# Response to reviewer and community comments for the article “Mass changes of the Antarctic Peninsula ice sheet and peripheral glaciers, 2007–2021 ”

We have received two well-informed reviews and one community comment which were overall positive and constructive. The two reviewers and Matt King had some minor comments which we have now thoroughly addressed. The following document details the changes we propose to improve the article, with comments in black and our answers in blue.

Figure A12: Elevation change rate difference between the elevation change map from Smith et al 2020 and the one from this study. The ZWA12 outlines are plotted in black and the numbers correspond to the associated subregion number (24 to 27). The RGI outlines are plotted in black.

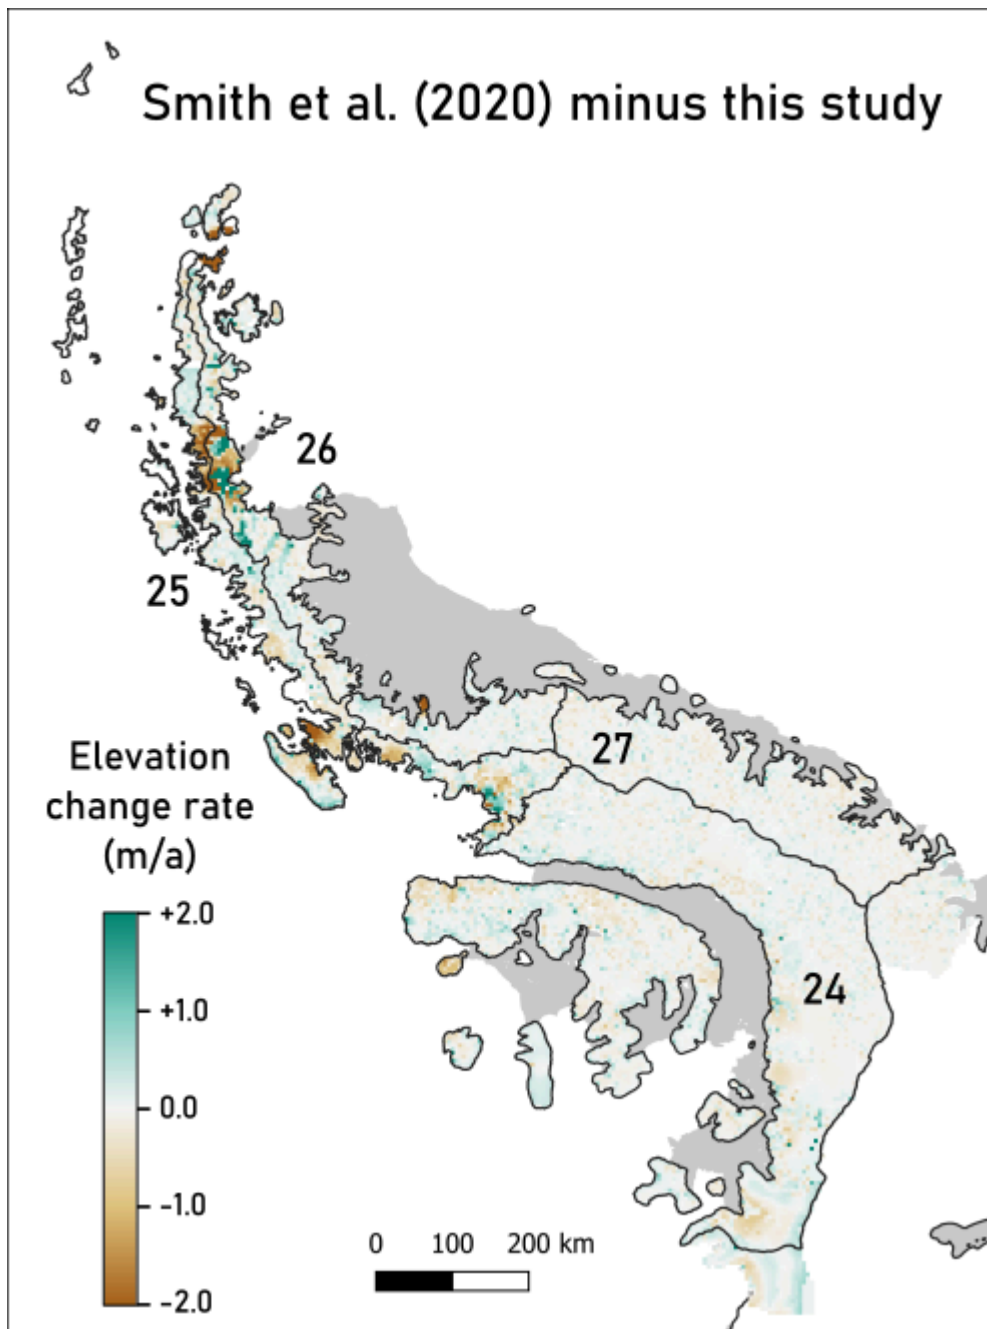
1. The authors report an AP Ice Sheet mass change of  $-26.5 \pm 5.3$  Gt/a, which is 4–5 times more negative than the IMBIE altimetry estimate of  $-5.2 \pm 2.3$  Gt/a. While the authors correctly attribute this discrepancy to the resolution limitations of satellite altimetry in mountainous terrain, the discussion would benefit from a more explicit spatial breakdown of where this difference originates.

We agree, and now add this discussion to the article. First, the IMBIE altimetry estimate is available as a time series over the AP, but does not provide spatialized data. The estimate is calculated as the average of several altimetry studies that cover different time periods, which do not match the one from this study. Therefore, a spatial attribution of the differences is not possible when comparing only to the IMBIE figures.

Second, the study from Smith et al., 2020 provides a  $dh/dt$  map using laser altimetry over the

period 2003-2019, which is close to the one from this study (2007-2021). To detail the spatial origin of this difference, we investigated the difference map between the two studies, presented in the figure below (Fig. A12), that we also added in the appendix of the article. Following this, we added a short paragraph in the section 5.2 *Mass changes of the AP* to detail this in the discussion (in **bold**) L535-549:

*“The differences between the altimetry estimates and the estimates based on DEM analysis, though both belong to the same elevation-differencing group of methods, can be attributed to a variety of sources. Altimetry studies tend to provide less negative mass change estimates (e.g. Schröder et al., 2019, Hassan et al., 2025), except for Smith et al. (2020), who obtained a mass change of  $-39 \pm 5$  Gt/a over the period 2003–2019. **Discrepancies between elevation change maps derived from altimetry and from DEMs differencing highly depend on the area considered. When comparing the maps from Smith et al. (2020) to the results from our study, the mean elevation change rate difference is negligible over the ZWA12 southern regions 24 and 27 (0.002 and 0.008 m/a respectively). Those two regions are the largest of the AP and present a gentle topography that is accurately captured by laser altimetry. However, the elevation change rate difference is much larger over northern regions 25 and 26, reaching -0.10 m/a and -0.14 m/a respectively. Two distinct spatial patterns explain these discrepancies. First, interpolation errors in laser altimetry propagate outliers, which are more likely to remain due to the complex topography. For example, a small part of the northern tip of the Trinity Peninsula alone accounts for an unrealistic mass change of 10 Gt/a in Smith et al. 2020’s study. Second, the limited spatial resolution generates a bimodal pattern observed on many intensely thinning glaciers, such as Hektoría, Drygalski and Fleming Glaciers. The most negative  $dh/dt$  values at low elevations (0-700 m) are overestimated, i.e. more positive, and the less negative  $dh/dt$  values at medium elevations (above 700 m) are underestimated, i.e. more negative, because of signal leakage. This systematically induces an overestimation of mean elevation change rates, up to 1.05 m/a (Crane Glacier) and 2.17 m/a (Hektoría Glacier) from the laser altimetry maps. Thus, if an apparent agreement can exist between laser altimetry and DEM differencing at AP scale, it is most likely coincidental and conceals significant spatial differences related to the methods’ limits.”***

Figure A6. **FAC elevation change rates from firn densification models (2007–2021).** The mean FAC elevation change rate is shown on (a), the standard deviation on (d) and the FAC elevation change rates coming from the different FDMs are plotted on (b), (c), (e) and (f).

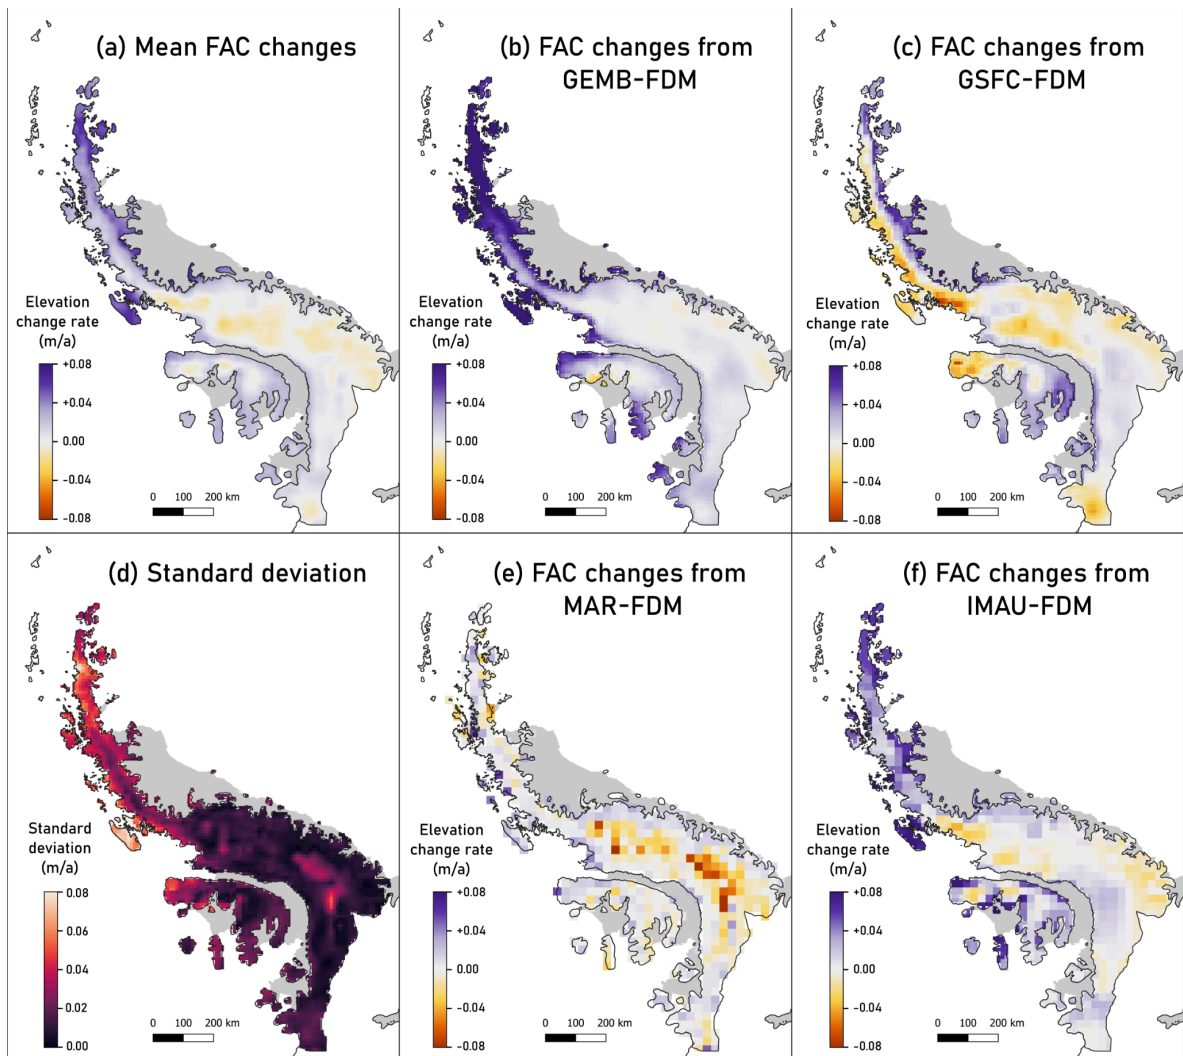
2. The FAC correction is identified as the largest source of uncertainty, yet the discussion of inter-model divergence remains brief. Since the authors already computed mass change outputs for all four FDMs individually, a short dedicated discussion of why these models diverge would be a valuable addition. In particular, are certain models known to perform better over the Peninsula, given its strong west–east climate gradient?

The models indeed present several differences, which are apparent in the appendix figure A6 (elevation changes due to FAC for each model). Regarding the East-West gradient, all the firm models considered (IMAU, MAR, GSFC and GEMB) do produce contrasted spatial patterns of FAC. Additionally, half of the models (GSFC-FDM and MAR-FDM) present contrasted spatial patterns of FAC change. Still, we note that even though the FAC maps should reflect this East-West gradient characteristic of the AP, it is not necessarily the case for the FAC change. The spatial resolution of the models also impacts the spatial size of the patterns that can be modeled. More precisely, MAR has a resolution of 27.5 km, IMAU of 27 km, GSFC of 12.5 km and GEMB of 10 km. The northern part of the AP, especially along the Trinity Peninsula, can be as narrow as 35 km, which is hardly resolved by the coarser models (MAR, IMAU) and frequently results in no data.

The decision we made in this study to use several FAC models instead of one chosen arbitrarily is also to report their spread and use it to quantify the uncertainties. Investigating in detail the origin of the firm models' divergences would require a study on its own, and goes beyond the scope of our article. Moreover, the FAC (and its temporal change) is poorly known at the AP scale and defining a best performing model is difficult considering the very limited amount of validation data.

To sum up the considerations mentioned above, we added the following sentences in the discussion L664-672: *“Given the short time period, which allows for limited densification and therefore limits the impact of the model densification choices, the likely sources of differences in FAC change are the forcing (as described in Mottram et al., 2021), surface parameterizations (e.g., surface snow density), and potentially the treatment of liquid water from melt and rain. The spatial resolution, ranging from 10 km (GEMB-FDM) to 27.5 km (MAR-FDM) may also affect the ability of the models to resolve small-scale spatial patterns, such as the East-West gradient across the AP. This is particularly visible in the northern AP, where the standard deviation between the models reaches its maximum (Fig. A6). The AP is a difficult place to validate climate and FDM models due to the scarcity of in situ measurements.”*

We also modified the appendix figure A6, adding the map of the standard deviation between the models, which facilitates identifying diverging areas.

Figure S1:  $dh/dt$  observations (left) and  $dh/dt$  complete map filled with interpolation (right) over Anvers Island. The SIL20 outlines are plotted in blue.

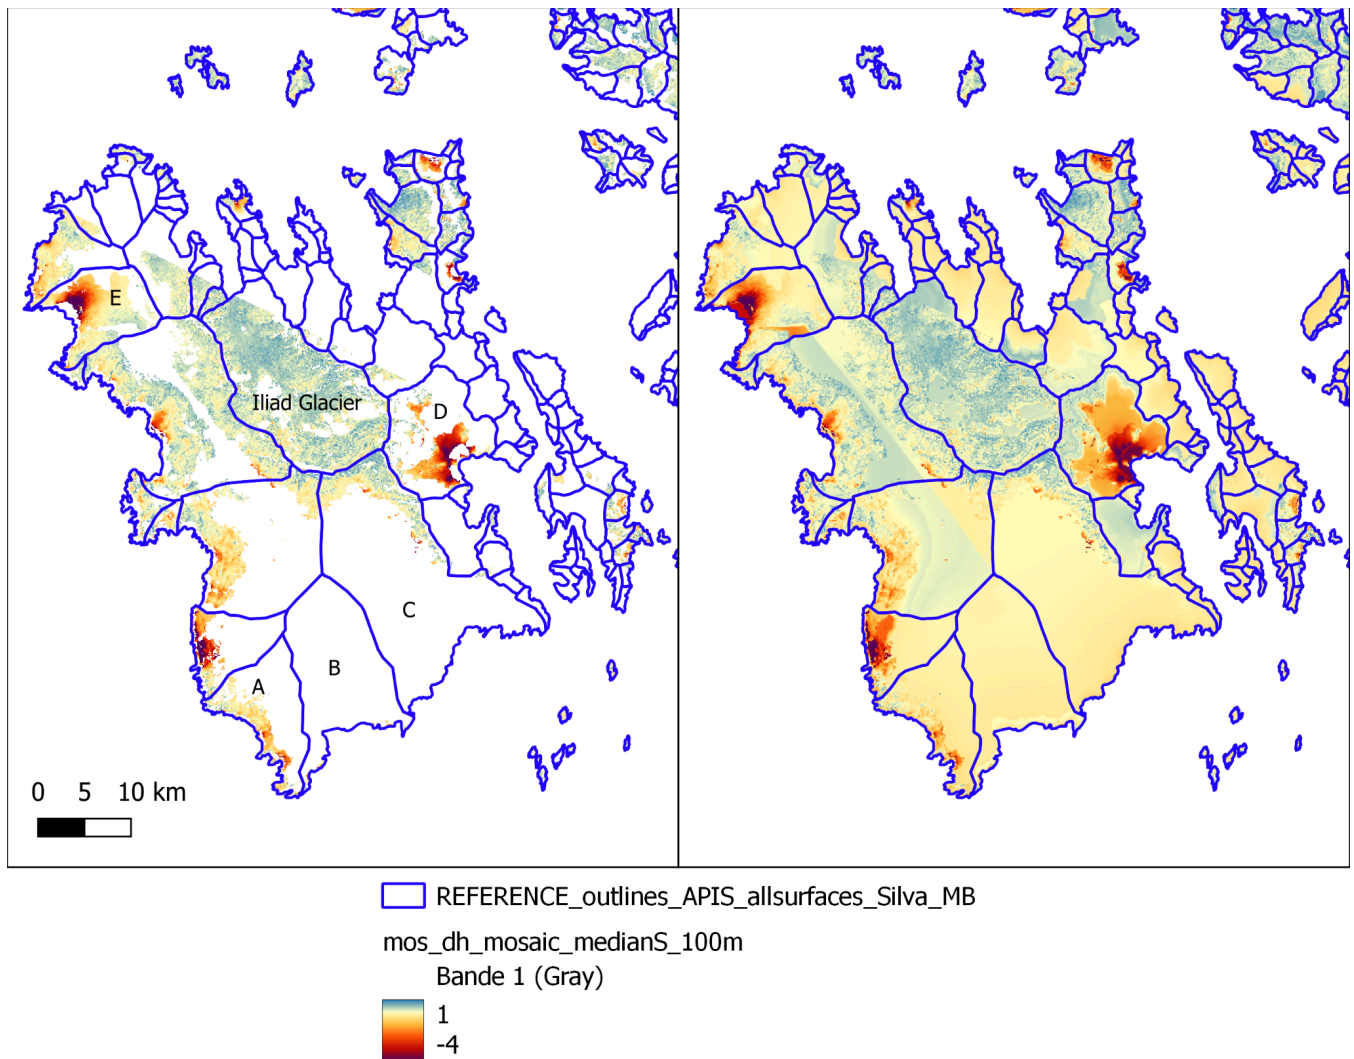
Fig. 7: it would be interesting to read more including an explanation for the very heterogeneous  $dh/dt$  values on Anvers Island, e.g Iliad Glacier and surroundings. It is shown in the map, but I could not find a corresponding section in the main text (L579 and following). Fig.4 shows a quite limited coverage whereas Fig.7 provides values for each glacier catchment. Do those heterogeneous values partially

come from the interpolation?

Thanks for pointing out this area which indeed presents interesting and contrasting spatial patterns. As the reviewer correctly observed, Anvers Island was partially covered by the  $dh/dt$  observations (30% of the total area of the island) and thus a substantial portion of it was filled with interpolation before calculating the mean elevation change per catchment (presented in Fig. 7). A zoom on this precise area is presented in Fig. S1 below. For example, the elevation changes of glaciers labeled A, B and C are poorly constrained and thus might not correctly reflect the real changes. Therefore, the apparent contrast between Iliad Glacier and Glaciers A/B/C mean ice elevation changes (Fig. 7) is very uncertain.

Nevertheless, some of the contrasting spatial patterns of  $dh/dt$  values in Anvers Island are not the result of interpolation. In particular, Glaciers D and E present very different  $dh/dt$  values from Iliad Glacier, which primarily come from observations and not interpolation. When averaged over the catchment, these differences in  $dh/dt$  lead to a notable difference in mean elevation changes (Fig. 7). We also note that many other areas in the AP present this kind of contrasted  $dh/dt$  patterns, in many cases not induced by the interpolation (e.g. the two neighbouring glaciers Stefan Ice Piedmont and Peter, or Cadman Glacier and its neighbors Fig. 7). This is also a consequence of the high spatial resolution that enables us to observe changes at glacier scale.

Last, this area is also of interest as it shows the dependency of the hypsometric interpolation method on the reference DEM used. Some artefacts in the TanDEM-X DEM appear clearly in the catchment West to Iliad Glacier. However, a sensibility analysis (comparison between the hypsometric interpolations obtained using the TanDEM-X DEM and the REMA DEM as a reference) proved the very limited impact of the reference DEM on the catchment mean elevation change.

To sum up these remarks, we added the following sentences (in **bold**) in the discussion L684-687: *“The local hypsometric interpolation performs well in smooth high altitude areas but struggles more reproducing local patterns of intense thinning at lower elevations (e.g. Drygalski or Fleming Glaciers). **If some of the contrasting  $dh/dt$  spatial patterns do reflect observations (e.g. Stefan Ice Piedmont and Peter Glaciers, Cadman Glacier, Fig. 7), the interpolation can artificially generate contrasted values, as in the south of Anvers Island (Fig. 7). Glaciers’ mean ice elevation changes must therefore be interpreted with caution, especially when  $dh/dt$  observations are scarce.**”*

Figure A7: **Elevation change rates from GIA models (2007-2021).** The mean GIA elevation change rate is shown on the panel (a), the standard deviation on panel (d) and the elevation change rates coming from the different models are plotted on the panels (b), (c) and (e).

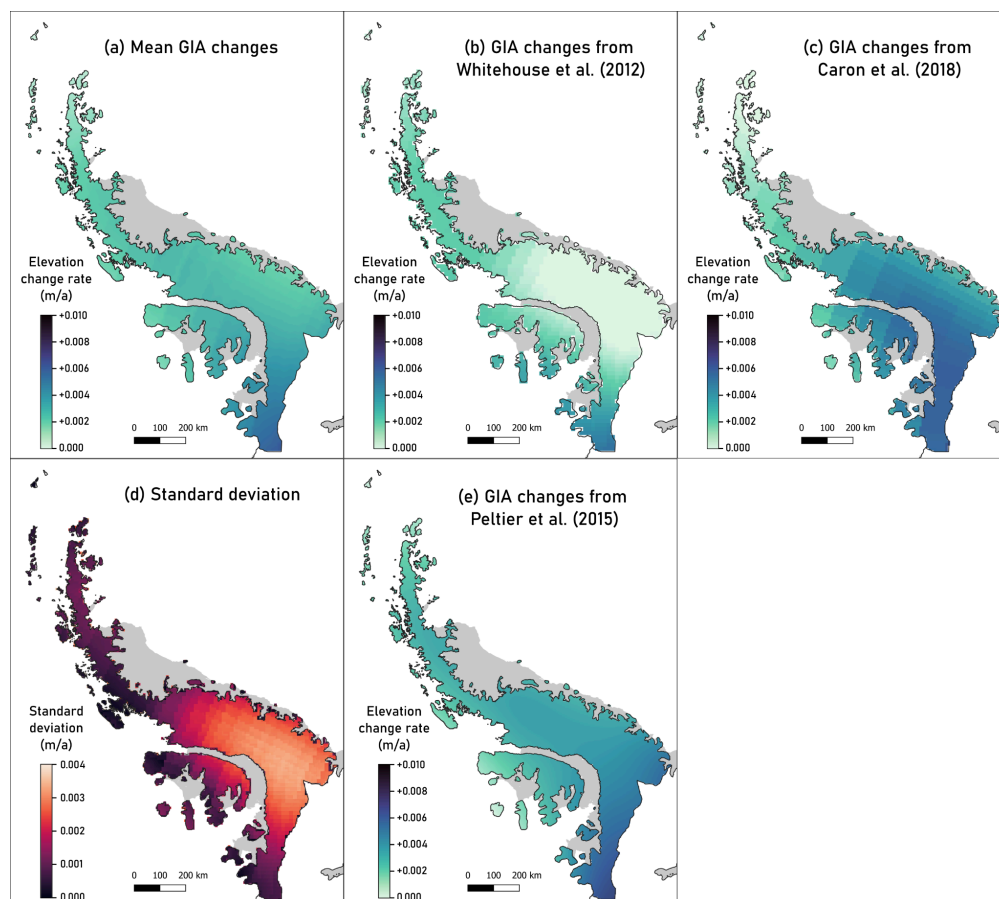
A brief comment on the adopted GIA models on what looks like a really nice paper. The millennial-scale GIA models are well known to be inaccurate in the Peninsula. I provide the references below. I think this is a secondary issue, but it does possibly need some quantification of the effect of this mismodelling, given that it is a systematic error.

Nield et al. 2014 <https://www.sciencedirect.com/science/article/pii/S0012821X14002519> (see Figure 4 where uplift rates are compared to ICE5G and IJ05R2). ICE6G would have similarly low agreement with the GPS uplifts.

Thanks for this interesting comment on crustal deformation. To clarify the crustal deformation processes that exist, we listed them in the table below. The two components that we included in our study are the **Glacial Isostatic Adjustment (GIA)** and the **Elastic Rebound (ELR)**. Note that the expression "Glacial Isostatic Adjustment" should be used for the total viscoelastic part of the table, but is commonly used for the long term component as the other components are not modeled. We also clarified this in the text L148-150: *"The term GIA is here used to describe the long term crustal viscoelastic response, i.e. related to the millennial-scale deglaciation, and does not include medium and short term evolutions such as since the Little Ice Age."*

The two articles mentioned highlight the importance of considering the recent visco-elastic response, induced from both medium term **(A)** and from short term **(B)** changes to reproduce the observed GNSS changes. In other words, they show that considering only the GIA + ELR is not sufficient to match the GNSS observations. However, modeling the recent viscoelastic response is not a straightforward task. To our knowledge (and we welcome direct exchange with Maat King if we are wrong), there is no dataset available that provides such results over the entire Antarctic Peninsula for the period considered (2007-2021). More generally, Nield et al. (2014) report a maximum uplift rate of  $14.9 \pm 2.7$  mm/yr at Foyn Point (FONP) between 2009 and 2012 while Samrat et al., (2022) report that *"The*

maximum observed uplift rate of  $\sim 12.4 \pm 0.2 \text{ mm yr}^{-1}$  was recorded at the DUPT station between 2009 and 2010. “ Those two stations, FONP and DUPT, are located in the northern AP. This region (corresponding to Regions 25 and 26 from Zwally et al., 2012 outlines) concentrates the most negative elevation changes (Fig. 6). The uncertainty largely comes from the FAC (Fig. A12) as models particularly diverge in this narrow part of the AP. The standard deviation of FAC models ranges between 3 to 6 cm/a in the northern AP. The maximum uplift rate is therefore three times lower than the firm related uncertainty in this region. Regarding the other regions (Regions 24 and 27 from Zwally et al., 2012 outlines), ice changes are less intense but the viscoelastic studies do not cover them, so it is complicated to derive any conclusion.

Therefore, we modified the appendix figure on GIA models (Fig. A7) to show the map of the spread between the models and enable to visualize spatial discrepancies. We also added the following sentences (in **bold**) in the discussion to more clearly mention the limits of the crustal deformation correction L651-656: “*The choice of a GIA or elastic rebound model has minor implications for the final volume changes. The associated corrections systematically represent less than 4% of the signal, and fall within the observational uncertainty. However, the crustal deformation corrections applied in the study (GIA and ELR) do not account for recent viscoelastic response, which might be required to fit with observed bedrock uplift rates (Nield et al., 2014; Samrat et al., 2022). The misfit induced could exceed the GIA and ELR signals in the northern Peninsula. Even if the signal amplitude remains lower than the firm-related uncertainty in this region (Fig. A6), future studies should consider applying a viscoelastic correction at the AP scale in order to account more accurately for crustal deformation.*”
